Initial Product/Process Change Notification Document #:IPCN22897X

Title of Change:	Conversion from existing PQFN8x8 Sawn-type package to PQFN8x8 Punch-type package (w/ 2mils Bare Cu wire, Large DC clip and wettable flank feature).		
Proposed First Ship date:	11 Apr 2020 or earlier if approved by customer		
Contact Information:	Contact your local ON Semiconductor Sales Office or < RamilAngelo.Nonato@onsemi.com >		
PCN Samples Contact:	Contact your local ON Semiconductor Sales Office or <pcn.samples@onsemi.com>. Sample requests are to be submitted no later than 30 days from the date of first notification, Initial PCN or Final PCN, for this change. Samples delivery timing will be subject to request date, sample quantity and special customer packing/label requirements.</pcn.samples@onsemi.com>		
Type of Notification:	This is an Initial Product/Process Change Notification (IPCN) sent to customers. An IPCN is an advance notification about an upcoming change and contains general information regarding the change details and devices affected. It also contains the preliminary reliability qualification plan. The completed qualification and characterization data will be included in the Final

3D Model Comparison

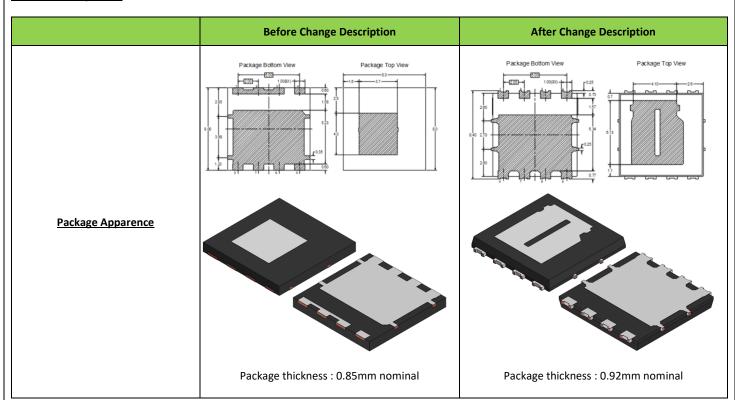
This Project is to convert the impacted PQFN 8x8 parts from Sawn package to Punch Package.

Before Change Description	After Change Description	
Lead Frame	Etched Type	Stamped Clip	
Bond Wire	1.5mils PCC/ Cu Clip 10mils with Cu Heatslug 20mils	2mils Cu wire/ 1pc Cu Clip 20mils	
Mold Compound	Hitachi CEL9240HF10LS	Sumitomo G700LTD SF
